Oyster Point Marina West Basin Access Improvements (Contract 2024-04)

ADDENDUM NO. 1 RESPONSE TO QUESTIONS

May 16, 2024

This ADDENDUM provides responses from the District to questions about the Invitation For Bids for Contract 2024-04, submitted by a prospective bidder.

DATE 04-10-2024
SHEET 8 OF 25
C-012

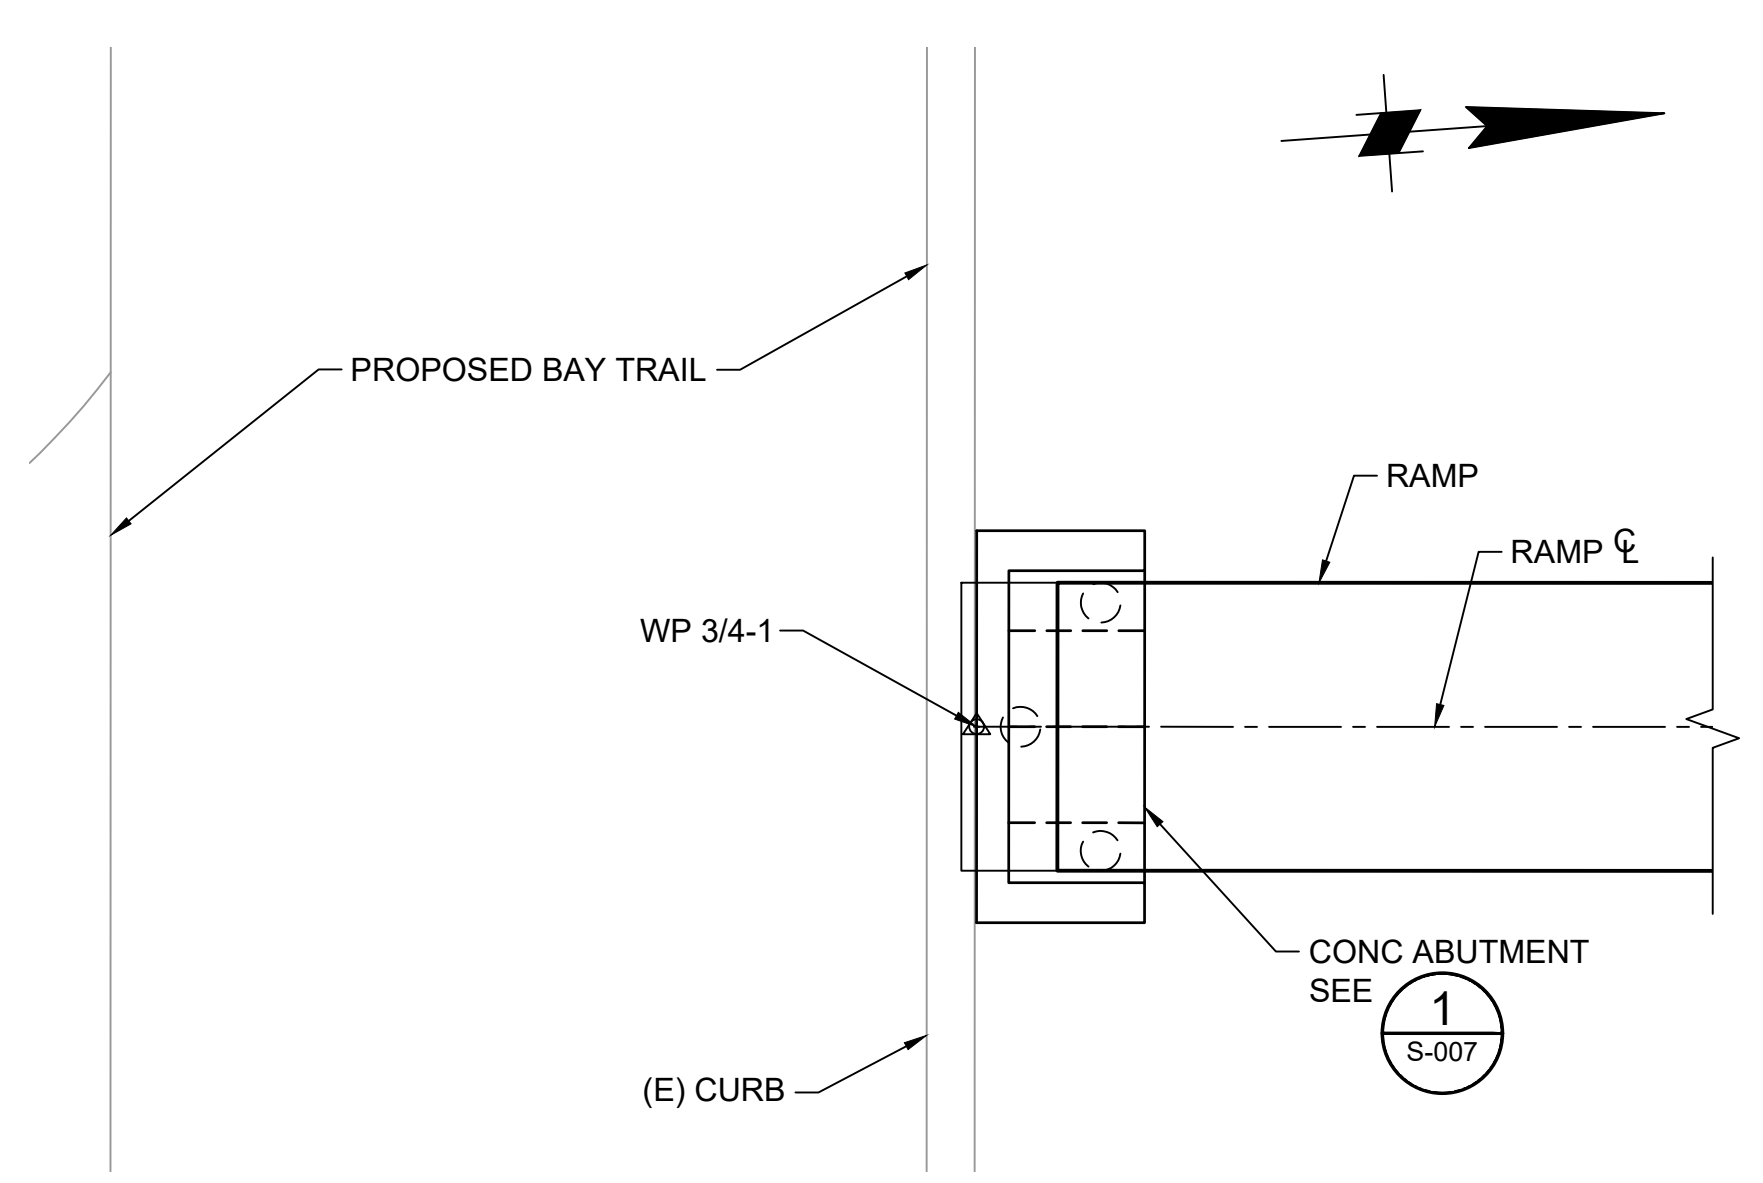
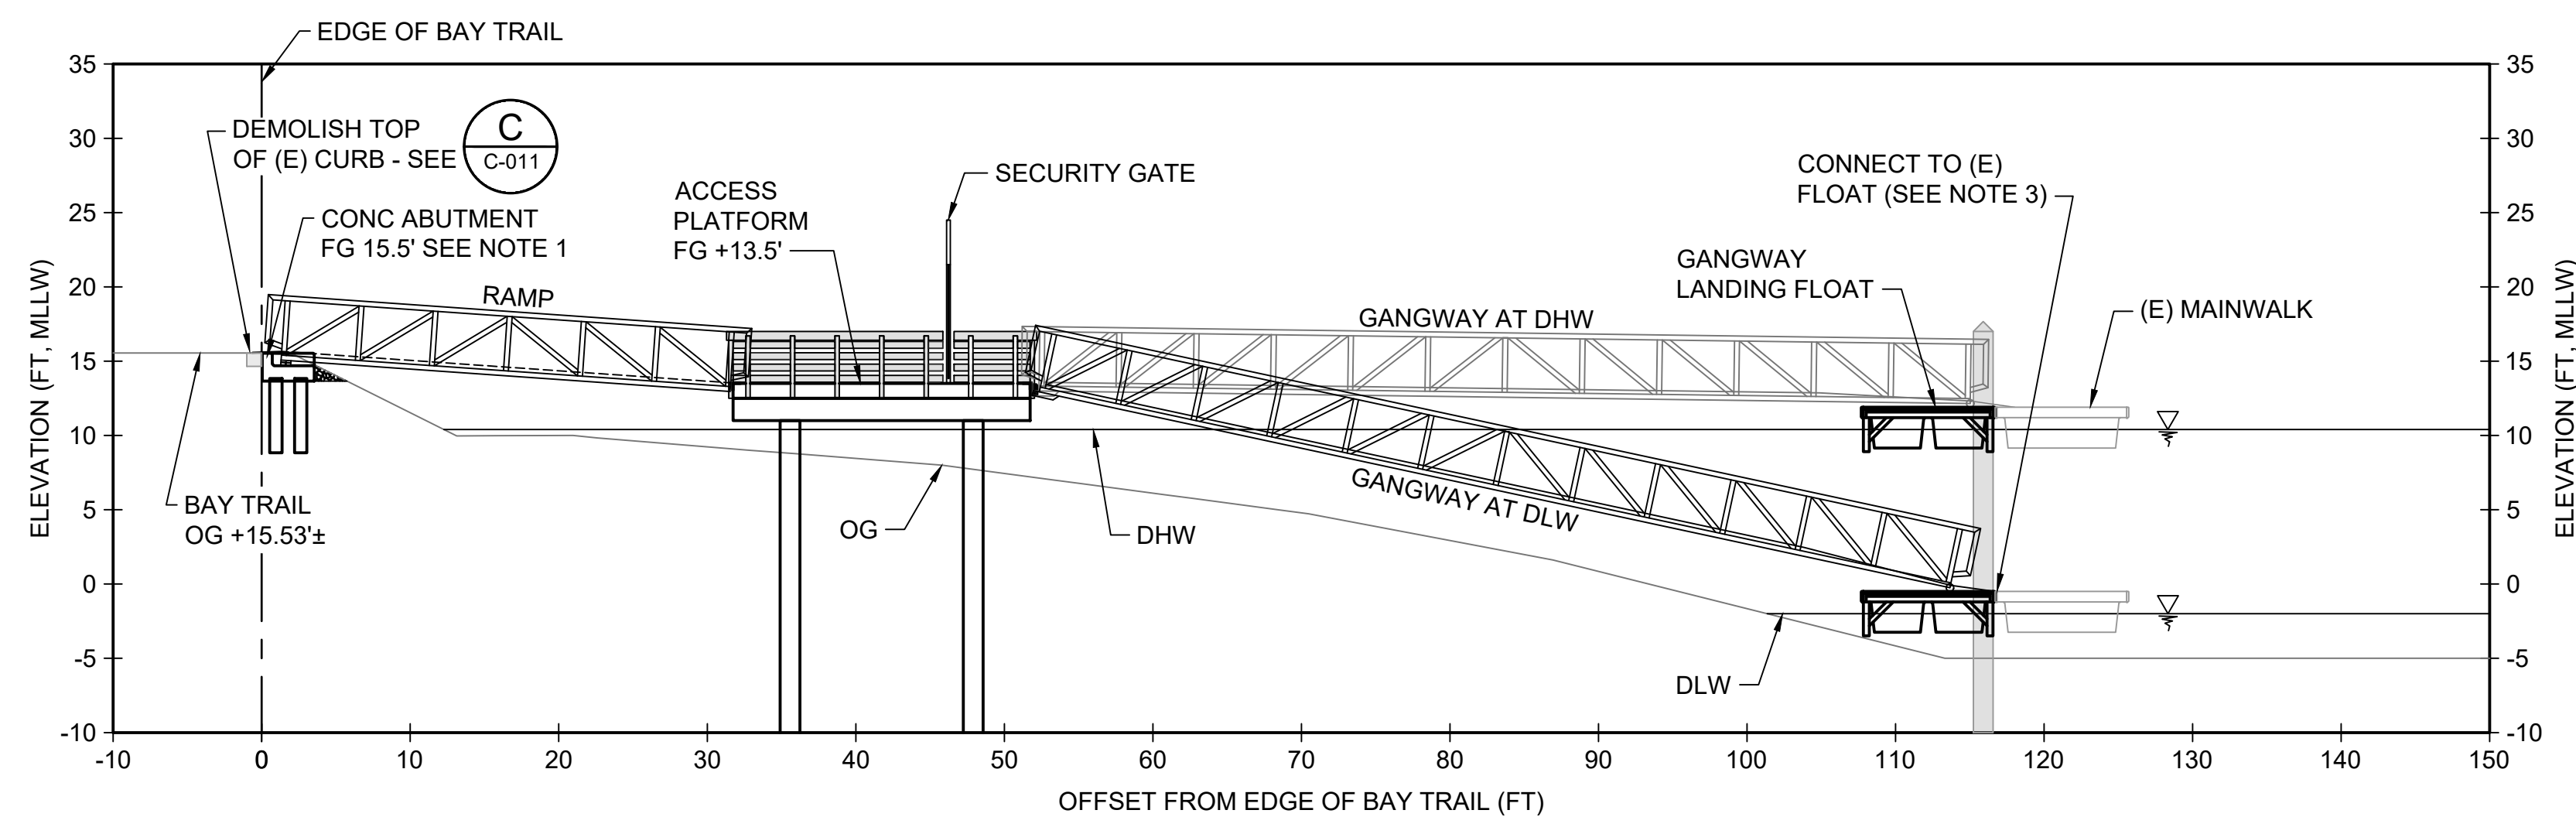
Question 14: The plans call for the gangway landing floats to be concrete floats. Spec Section 024800-7 Part 2 provides a list of acceptable floats to be used for various types of floats such as concrete, timber, and aluminum. Please clarify if these gangway landing floats are to be concrete floats.

Drawing sheet C-012 "Docks 3 & 4 – Dock Access Plan & Elevation":

1. Plan View:
 - a. Revise callout from "9' x 16' concrete landing float" to "9' x 16' gangway landing float (see note 3)."

District response: The gangway landing floats may be concrete, timber, or aluminum as specified. Plan view callouts on sheets C-12 and C-13 will be revised from "concrete landing float" to "gangway landing float."

DATE 04-10-2024
SHEET 9 OF 25
C-013

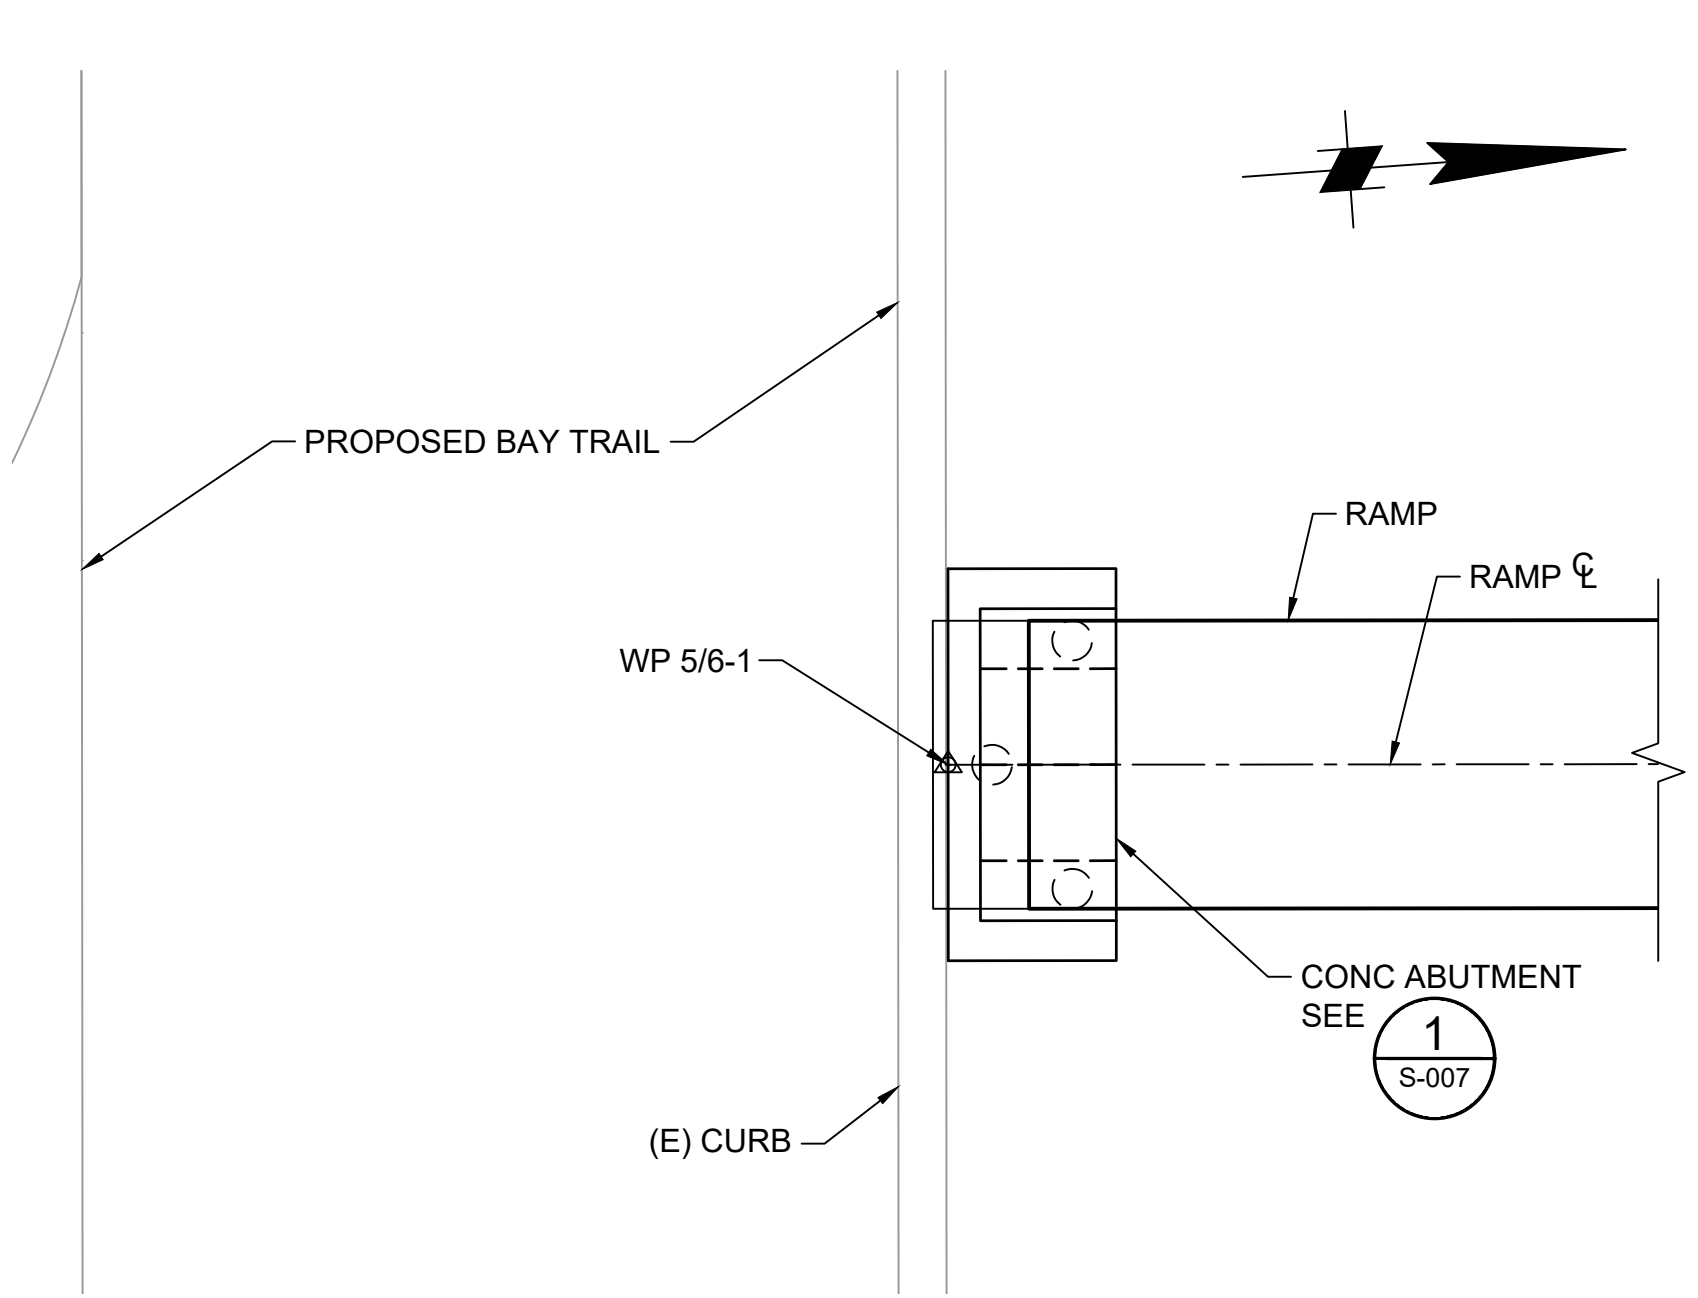
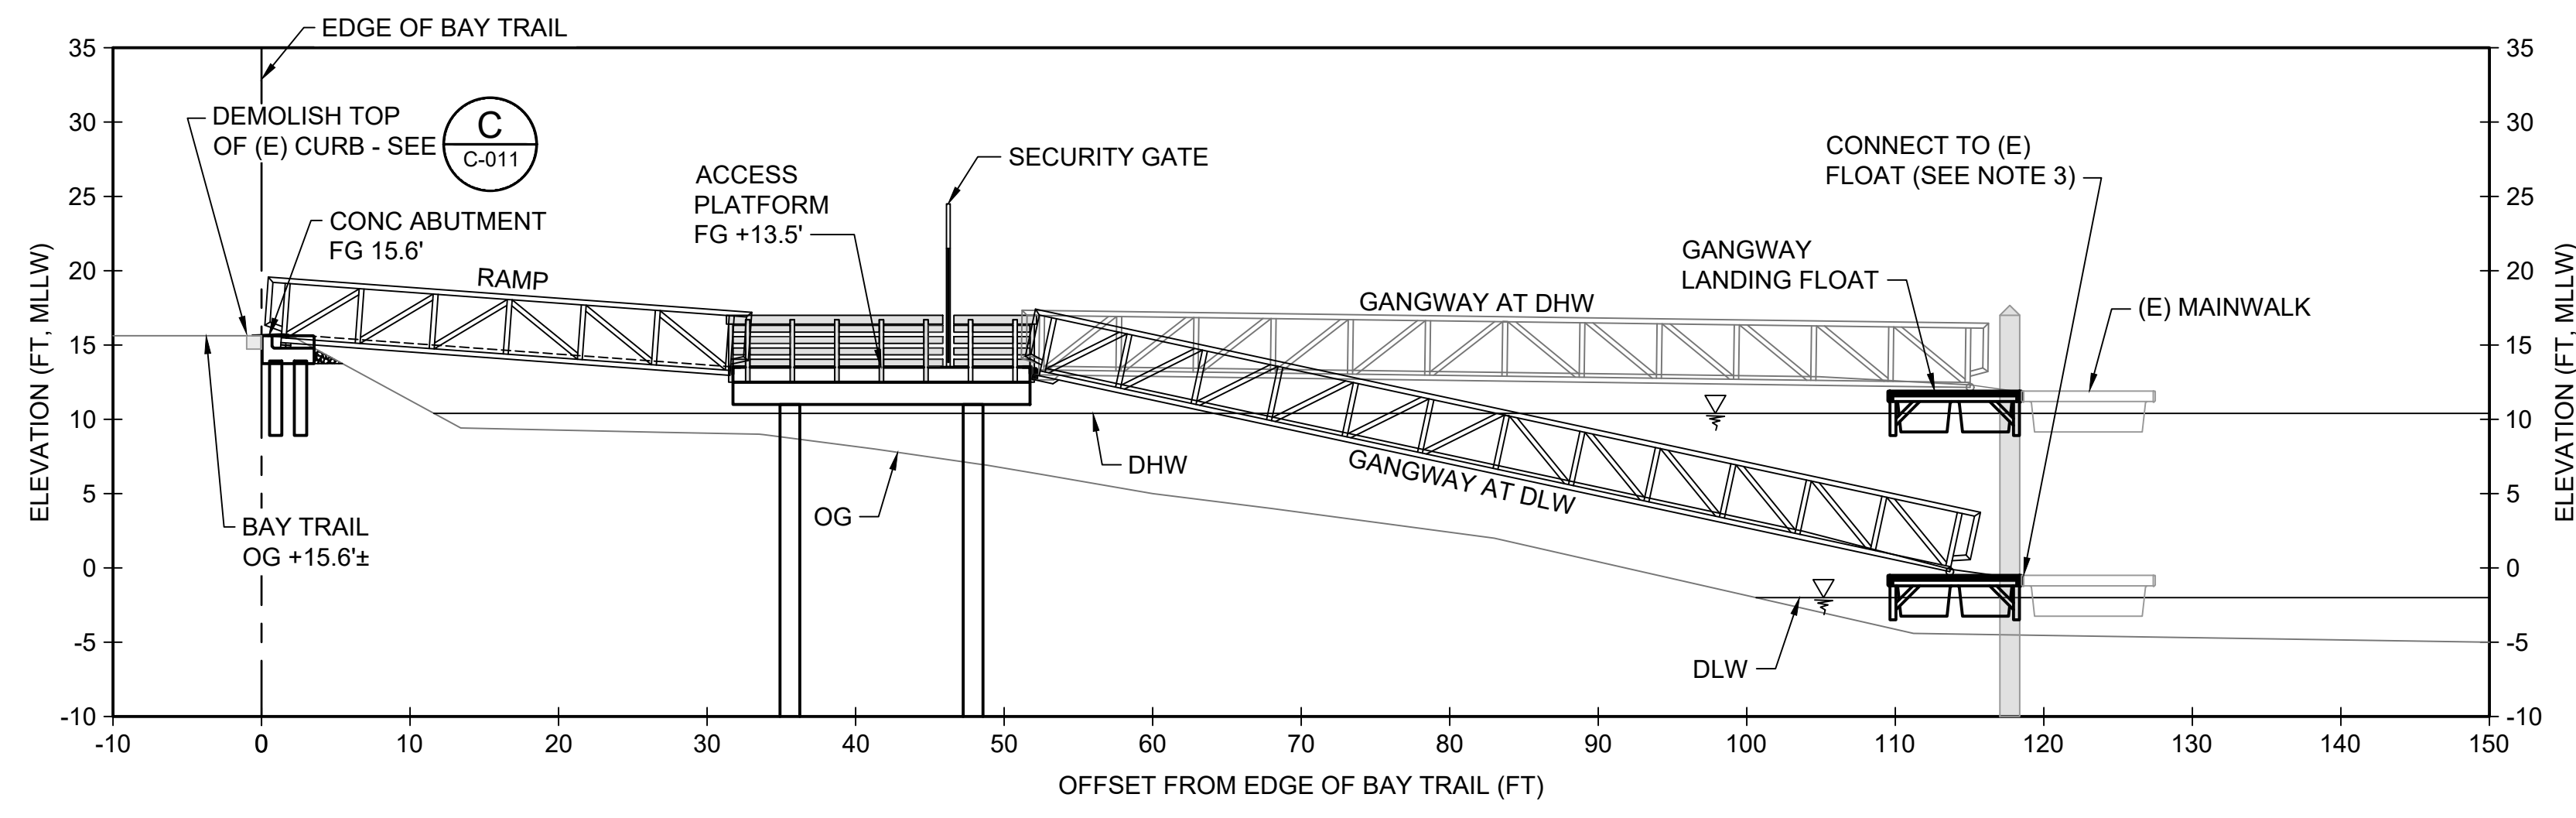
Drawing sheet C-013 "Docks 3 & 4 – Dock Access Plan & Elevation":

1. Plan View:
 - a. Revise callout from "9' x 16' concrete landing float" to "9' x 16' gangway landing float (see note 3)."

1 16 INCH DIA STEEL PIPE PILE ELEVATION
SCALE: 1" = 1'-0"

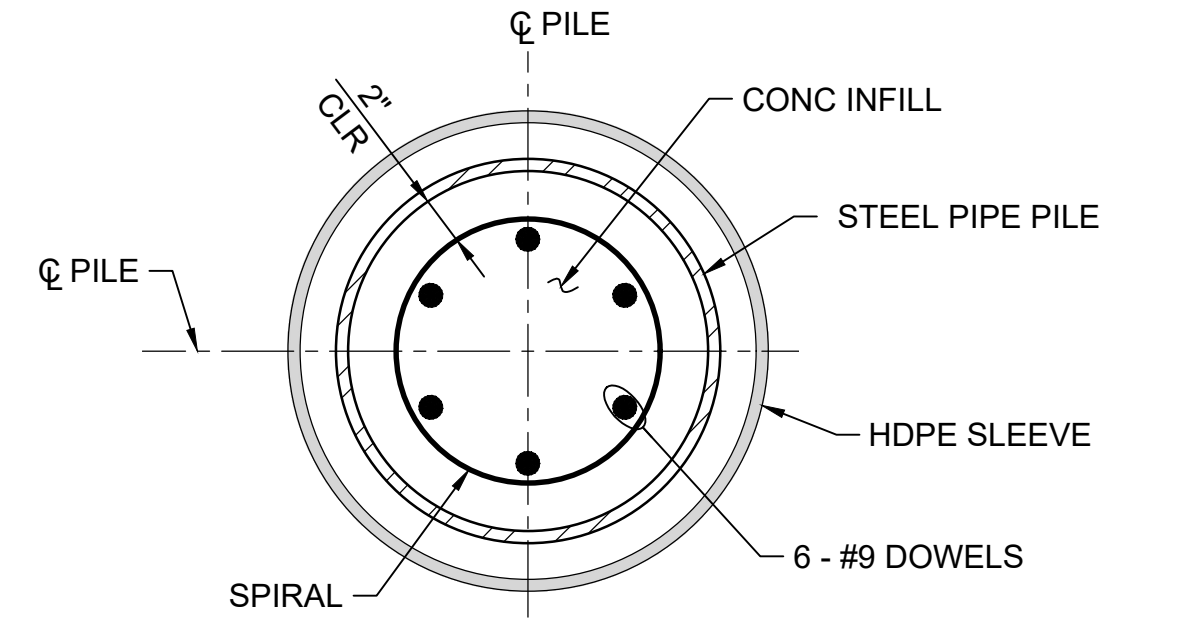
Question 16: Please provide a pile length schedule to confirm exact pile lengths at each location, to ensure bidders price the same quantities.

Drawing sheet S-004 “Access Platform Pile Details”:

1. Detail 1 “16 INCH DIA STEEL PIPE PILE ELEVATION”:

a. Revise callout from “PILE TIP EL -115” to “PILE TIP EL -114”

District response: Piles are 125' long. The pile tip elevation has been raised from -115' to -114'.
